**FIELD VARIANCE FORM**

<b>DATE:</b> 6-OCT-11	<b>PROJECT NAME:</b> Interim Action Ranges (IAR) Munitions Response Area (MRA)	<b>PROJECT LOCATION:</b> Interim Action Ranges
<b>APPLICABLE DOCUMENT / SECTION:</b>	Final Phase II Interim Action Work Plan, Interim Action Ranges Munitions Response Area, Former Fort Ord, dated May 24, 2011	
<b>SUBJECT:</b>	Interim Remedial Action Recommended for Range 47 Special Case Area

Figure 1

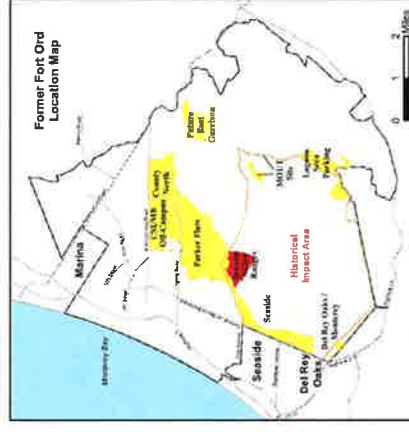
The Design Study for Range 47 (R47) Special Case Area (SCA) has been completed in accordance with the Final Phase II Interim Action Work Plan for the Interim Action Ranges Munitions Response Area (IAR MRA) and Field Variance Form No. IARWP-002 for excavation and screening of the berm (Figure 1).
